REVIEW OF DETERMINATION ASSESSMENT REPORT

Application Number:	REV2022/0011
----------------------------	--------------

Responsible Officer:	Olivia Ramage
Land to be developed (Address):	Lot 171 DP 709495, 14 Prince Alfred Parade NEWPORT NSW 2106
Proposed Development:	Alterations and additions to a dwelling house
Zoning:	C4 Environmental Living
Development Permissible:	Yes
Existing Use Rights:	No
Consent Authority:	Northern Beaches Council
Delegation Level:	DDP
Land and Environment Court Action:	No
Owner:	Corri Jane Marshall Stene Marshall
Applicant:	Grant Vallack

Figure 1 - South Elevation showing Envelope Breach

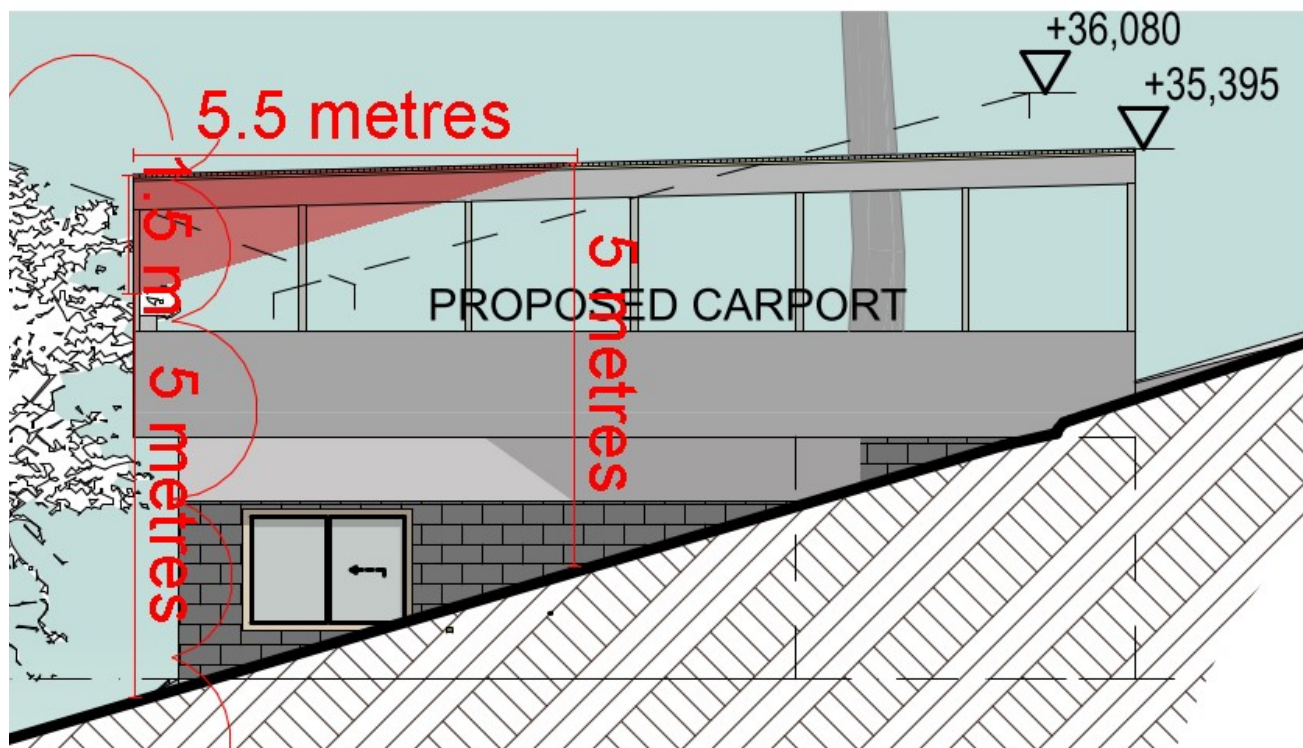
The proposed development breaches the envelope on the southern elevation between nil and 1.5 metres for a length of 5.5 metres.

The proposed carport is open on all sides which ensures the bulk and scale of the built form is minimised. The structure complies with the height of buildings standard and is of a scale compatible with the surrounding development. As such, the bulk and scale of the built form is minimised.

The proposed carport is an open structure with a flat roof and will therefore, preserve views and vistas.

The proposed carport provides appropriate setbacks to the northern and southern side boundaries which ensures adequate spatial separation from nearby properties. A detailed assessment of solar access and privacy is provided under Clause C1.4 and C1.5 respectively.
